APPLICATION NO.	FILING DATE	FIRST NAMED INVENTOR	ATTORNEY DOCKET NO.	CONFIRMATION NO.
10/707,273	12/02/2003	Anders Larsson	07589.0081.NPUS01	1272
28694	7590	03/08/2006		
NOVAK DRUCE & QUIGG, LLP 1300 EYE STREET NW 400 EAST TOWER WASHINGTON, DC 20005			EXAMINER EDGAR, RICHARD A	
			ART UNIT 3745	PAPER NUMBER

Office Action Summary	Application No. 10/707,273	Applicant(s) LARSSON, ANDERS	
	Examiner Richard Edgar	Art Unit 3745

Figure 1

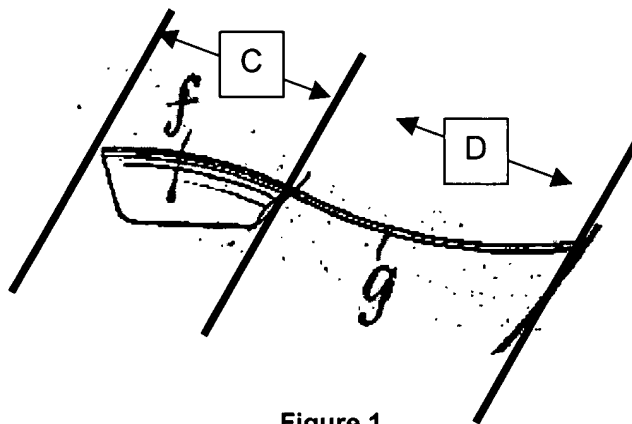
Capell shows a closed-type centrifugal impeller having in Fig. 3 (right-side embodiment) blades *g* extending in the radial direction wherein the radially inner portion of the blade is concave in the direction of rotation and the radially outer portion of the blade is convex in the direction of rotation. As seen in Fig. 3 (right-side) the blade *g* extends to the periphery of the impeller. As can be seen from Figure 1 below, the radially inner curved portion (C) is shorter than the radially outer curved portion (D). The length of C is between 10-40% the length of C+D. The impeller is of a closed-type with a central opening (see Figs.). Capell teaches that the blades may be inclined forward (see page 1, lines 77-80).
